Report to the Future Melbourne (Planning) Committee

Agenda item 6.2

Ministerial Planning Referral: TPM-2013-10 464-466 Collins Street and 83 William Street, Melbourne 3 December 2013

PLANNING REPORT MINISTERIAL REFERRAL

REAR LANEWAY

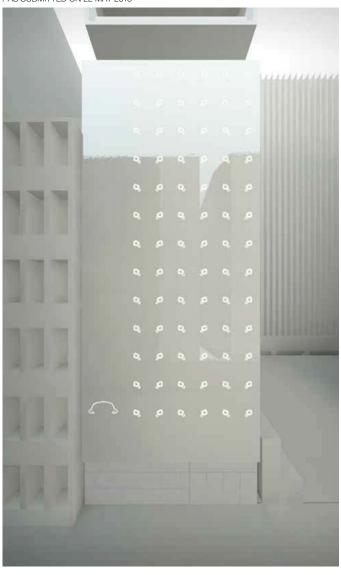
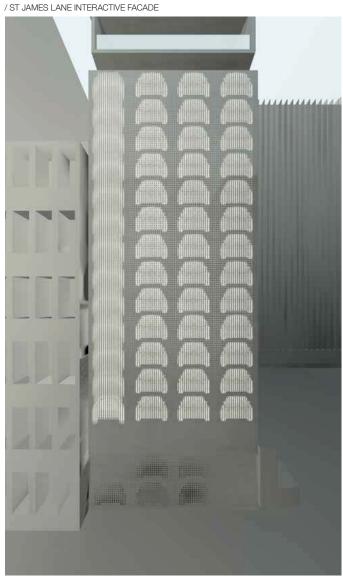
Melbourne 16 September 2013) and supplementary information received on 6 November 2013. The supplementary information includes a change to the west elevation of the tower so that it fully abuts the west boundary of the site and incorporates circular boundary windows in random positions. The information received on 6 November 2013 also includes a change to the rear elevation at the car park levels.

South Elevation TP_04_01

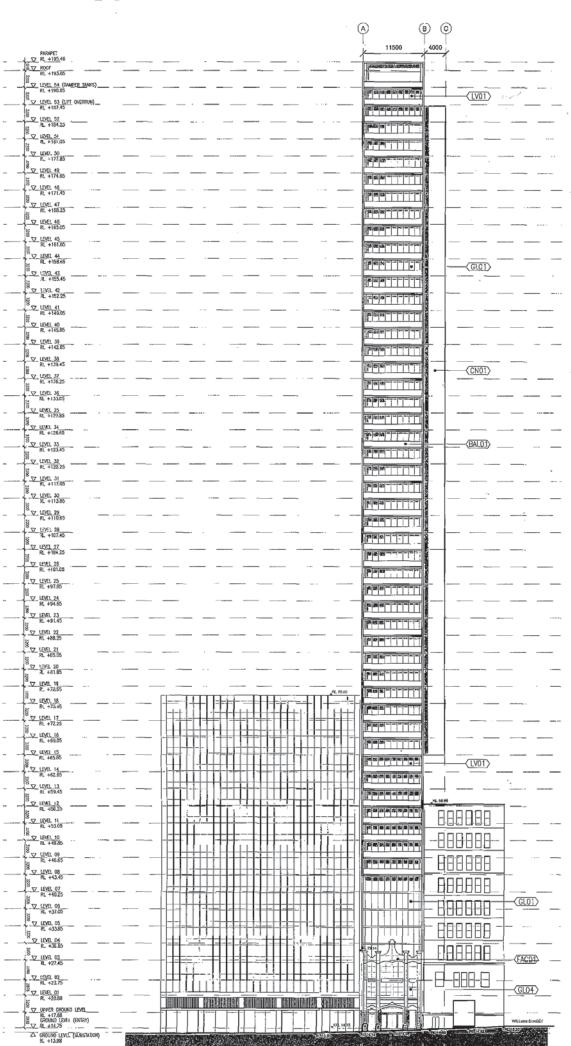
- 3.2 The front setback of the tower of 4-6 metres is insufficient, resulting in a building which is visually intrusive and dominant from the Collins Street public realm. The inadequate front setback will result in the existing building at 464-466 Collins Street being seen as a token heritage facade in front of a modern tower.

- 4 m front setback (above level 7) is inadequate. Impact of tower will be a composite of height and lack of setbacks.
- Tower should be set back at least 6 m (preferably more). This should include setting back both wall and balconies.

- The restoration of the facade of the existing building will notably enhance its heritage significance.
- Proposed tower setback, approximately aligning with the facade of 470 Collins Street will present the frontage of the existing building cut off by a wall of modern buildings. The sense and perception of the building's integrity will be destroyed by the limited setback. The prominence of proposed addition undermines any argument that it will be reasonably perceived to be behind the host. Remnant heritage building will be seen as a token heritage frontage in front of a modern tower. The standard of retaining the perception of the integrity of the building frontage is not respected.

- Image of proposed building from west makes it clear that existing building will
 present as only the front room depth standing in front of the wall of modern
 buildings. Will present as token retention of heritage building.

- A setback of 8 metres may satisfy the need to retain a sense of integrity of the host and demonstrate suitable regard and respect for its significance. This could perhaps reduce to 6 m for level 8 and 4 metres from level 10 upwards. Without compelling and verifiable reasons why setbacks should be reduced in response to particular and extraordinary conditions of this case, setbacks of 8 m to at least level 7, 6m to levels 8-9 and then 4 m above should be imposed.

East Elevation TP_04_03

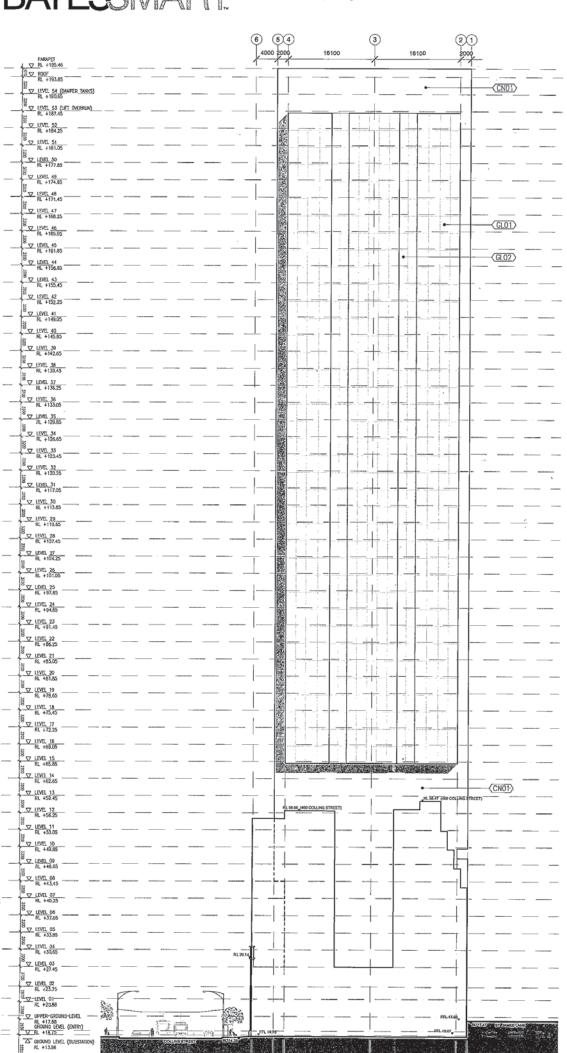
The proposed tower has no setback from the western boundary. This design does not appropriately respond to the principle of considering the development potential of adjoining sites. A 'Development Constraints Diagram' forming part of the application submission states that 470 Collins Street is:

This model of possible future development is contrary to Clause 22.01, requiring spacing between towers. If the development of 464 Collins Street were approved to abut the western boundary, future responsibility for providing tower separation would have to be borne solely by 470 Collins Street. The provision of west facing boundary windows as the only source of light to two bedrooms (and one bathroom) per floor also places an onus upon 470 Collins Street to protect these bedroom windows in the event of future development. Approval of this lack of side setback would impose an unreasonable and inequitable burden upon 470 Collins Street, compromising its development potential. These issues have been raised with the applicant, who has advised Council officers that it has attempted unsuccessfully to acquire air rights over the property to the west in order to increase options for providing daylight to habitable rooms. It is the applicant's intention to re-arrange the internal layout of units after a permit has been granted and marketing has commenced, both to respond to market demand for units of varying size and to eliminate reliance on borrowed light to habitable rooms.

North Elevation TP_04_02

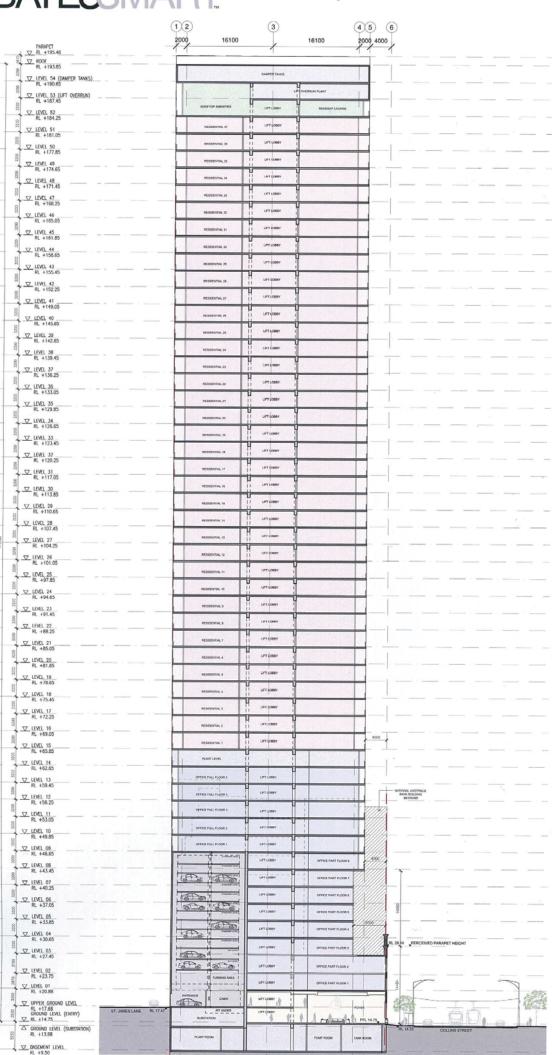
The east and west walls of the tower are built to the rear boundary of the site. The northern facade of the tower is set back 1-2 metres from the rear boundary. This

design is contrary to the above policy. The height of the tower and its lack of setbacks will not ensure a sense of openness and human scale along the laneway.

The lack of setback from the rear boundary fails to respond to the principle under Clause 22.01 of considering the development potential of adjoining sites. As with the lack of setback from the east boundary, the lack of setback from the rear boundary places responsibility for tower separation solely upon the adjacent site (91 William Street). The applicant's 'Development Constraints Diagram' refers to 91 William Street as a 'Potential development site. Unlikely to be a tall tower due to site size'. 91 William Street is 657 square metres in area while 464 Collins Street is 483 square metres in area. It is unreasonable to assume that 91 William Street could not accommodate a tower, give its site area and the fact that it is occupied by an ungraded building.

- Minimum of 10 m from Collins Street and William Street boundaries.
- 6.7m from St James Lane (the width of the lane). This would result in a separation of approximately 20 m from a future tower at 91-97 William Street.
- 10 m from west boundary (which would leave virtually no floor plate), unless air rights are acquired over 470 Collins Street, in which case setback from west boundary could be zero (or indeed the tower could project over the west boundary).

Upper Ground Floor (St. James Lane) TP_02_03 Rev B

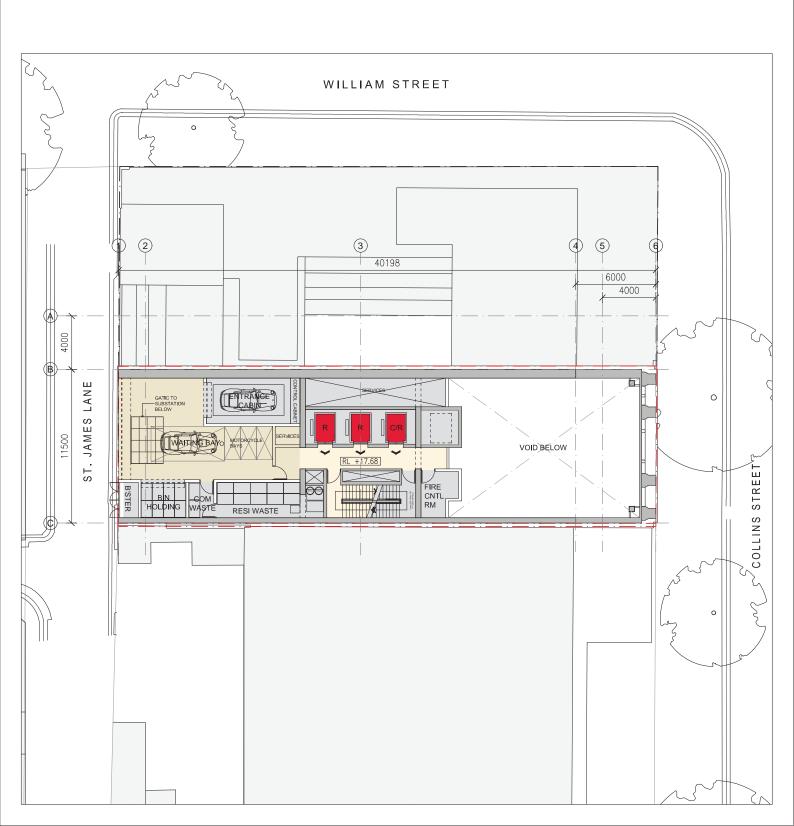
- Adequate number of bicycle spaces are provided, based on use of LEDA Compact Bicycle Rack system.
- Width of motorcycle access way should be increased from 1.5 m to 3.2 m.

- To provide adequate pedestrian/vehicle sightlines, either pedestrian splays should be provided or signage and flashing warning device to alert pedestrians of exiting vehicles and vice versa. Mirrors should also be installed just inside the property line to ensure that exiting motorists can see pedestrians approaching.

- Confirmation regarding layout of turntable for car stacker is required.
- Use of the car stacker will result in up to 3 vehicles queuing in St James Lane. As the entrance to the car park is located about 15 m west of the William Street building line it is only possible to store 2 vehicles in the lane with a third vehicle protruding onto the William Street footpath and obstructing the path of pedestrians. Given that St James Lane currently carries 25 vehicles per hour in the morning peak, these vehicles would queue behind vehicles waiting to enter the car park. This would impede traffic flow along William Street which is considered extremely hazardous given the Clearway restrictions along the street and the close proximity to the intersection at Collins Street. Given the above, ESG strongly objects to the proposed access arrangements including the proposed car stacker system. An alternative proposal must be submitted, to the satisfaction of Manager Engineering Services, which would ensure that the 98% queue does not extend into St James Lane and that any queuing can be accommodated inside the site.
